Palm Lane Residences

Project Address: 7320 E Palm Lane

RE: **6-ZN-2024**

Palm Lane Towns - Phase 2 ZN
J6073 (Key Code)

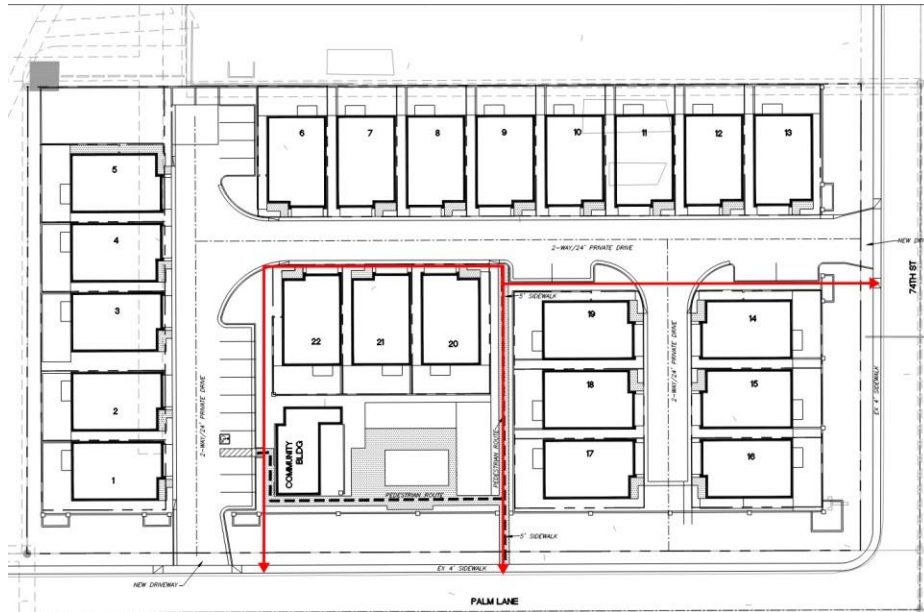
9. Walls taller than 3-feet in height shall not be located within the required frontage open space area, per ZO Sec. 5.704.F.1. Please address with resubmittal.

Response: No walls taller than 3' are located on the frontage open space – see site plan. The only 3' high 'walls' are the raised 2' high planters located at the entrances by the driveways

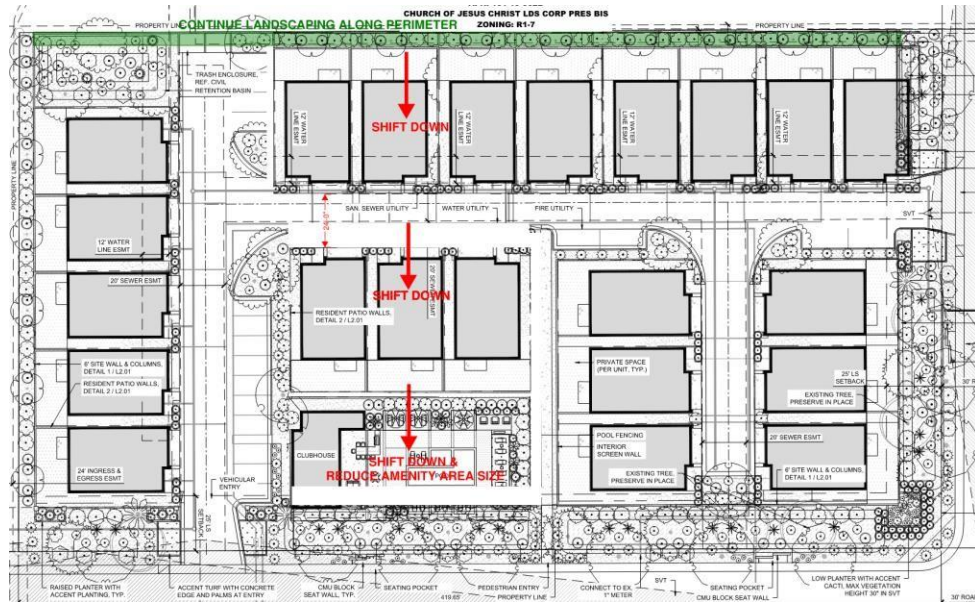
11. The proposed pedestrian connectivity plan does not appear to provide a safe and convenient network over the development site. Please update the proposal to include sidewalk connections near the driveway entrances to avoid shared pedestrian & vehicle access points consistent with ZO Sec. 1.904.A.3 (DRB Criteria #3 – Ingress, Egress, On-Site Circulation, Parking, and Pedestrians).

Response: New sidewalks have been incorporated in the site plan per notes. With conversations with planners and staff we agree to provide 4' wide sidewalks on the interior of the site. The exterior sidewalks and connections will be 6' wide sidewalks to the property lines. See site plan and circulation plan

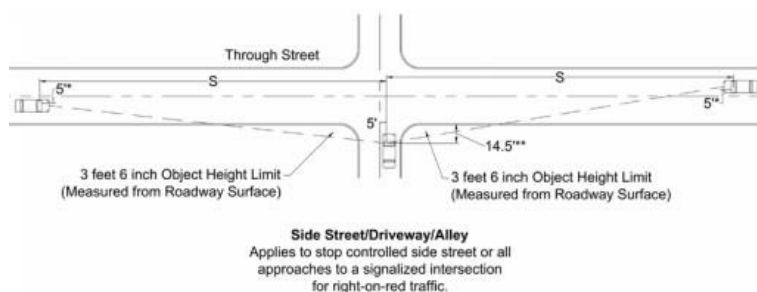
33. Please update the site plan with a min. 6-foot-wide sidewalk from the main entry of the development to each 74th and Palm Lane, per DSPM 2-1.310. Please be advised that a min. 5' is not acceptable and no connection is proposed to 74th. Please update all case materials in conformance with this development requirement.

Response: all public sidewalks to the site exterior site walls have been updated to 6' wide. See site plan and circulation plan
